Los Angeles County
Department of Regional Planning

**Project No. R2014-02411-(5) – Minor Conditional Use Permit No. 201400014
Oak Tree Permit No. 201400035 - Environmental Assessment No. 201400194
RPC Meeting: September 7, 2016 - Agenda Item: 6
Additional Materials**

The above-mentioned item is a request to construct a single-family residence on a hillside within the Altadena Community Standards District and includes one oak tree removal and encroachments into the protected zone of nine other oak trees. The request was approved by the Hearing Officer on April 19, 2016 and was appealed on May 2, 2016 by Randall Baer on behalf of the Canyon Crest Conservancy.

Same view after with the proposed N.W. corner of the "cellar" and balcony.

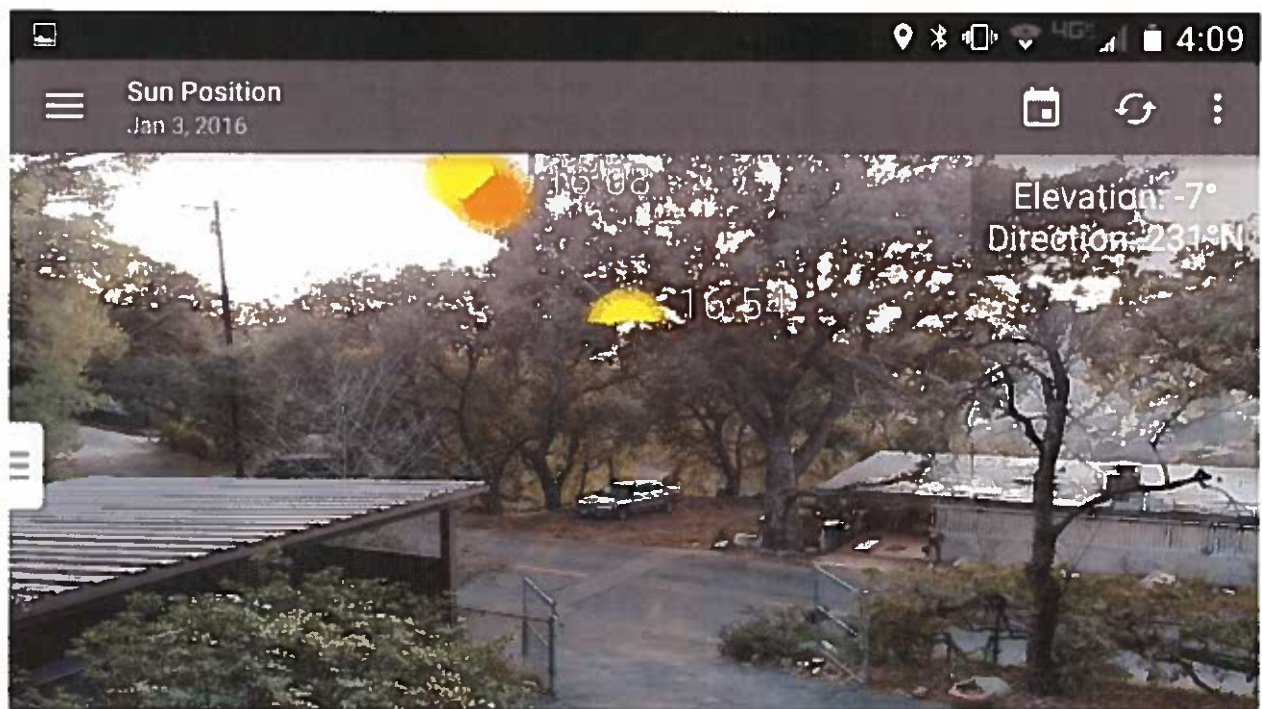
2.) There will be a significant impact on the aesthetic of the neighborhood. The proposed project was designed to look like a blank industrial warehouse with all metal surfaces and no windows facing our property. The proposed structure will tower over 6 times the height of our home at street level and will cascade another 31' into the canyon, well above and below all the other canyon side homes. Whenever we walk out on our patio or look out our living room windows we will literally be greeted by our neighbor's metal backside, instead of our current panoramic views. The proposed modern-industrial design would permanently change the aesthetic of this rustic neighborhood that was first developed in the early to mid-20th century. There are no other structures of this style that exist in our neighborhood or all of Altadena. No EIR has been done to date which is a violation of CEQA. Therefore the application is deficient and should be denied.
